Access Compliance Report Public Rights-of-Way (Curb Ramps)

Main Street: VAN_BUREN_ST		Cross Street: MCFADDEN_AVE		Location:	SW
ADA ID: RPRK220202115610	Ramp Type: Type 4 - Parallel	Initial Pass/Fail: Pass	Overall Compliance: No	Severity Score:	0
Codes/Mitigation Info/Possible Solution			Field Measurements/Component Compliance

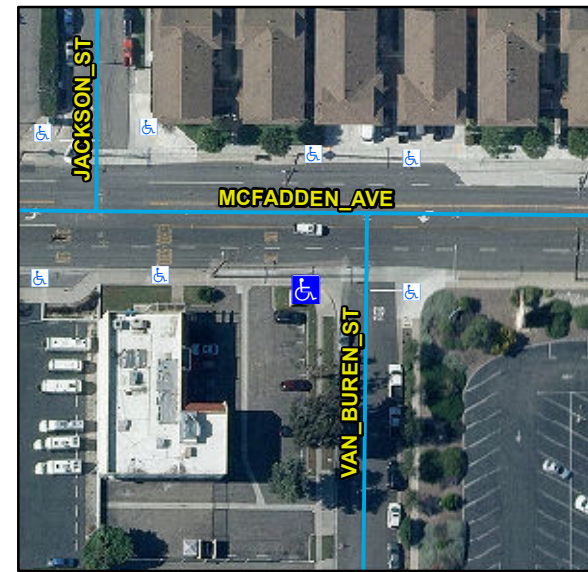
R304.2.2-Perp, R304.3.2-Para, R305.2, STD 1115

Remove & Replace Curb Ramp With Two New Directional Ramps or Equivalent.
